TECHNICAL BULLETIN

[Issue No.] T11-0012-A

[Title] Product discontinuation of Q series digital-analog converter modules

[Relevant Models] Q62DA, Q64DA, Q68DAV, Q68DAI

Fig 5.1. Limit of output current for the discontinued models

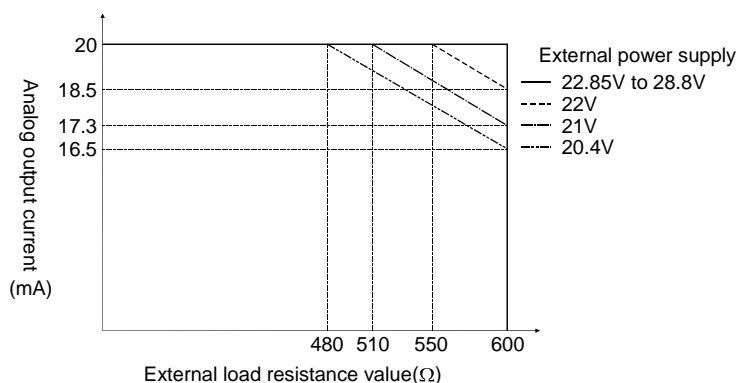
(1) Releasing a limit of output current

In the discontinued models, when the voltage of the external power supply is less than 22.85V DC, the analog output current and the external load resistance value are limited as follows. However, the alternative models do not have the limit.
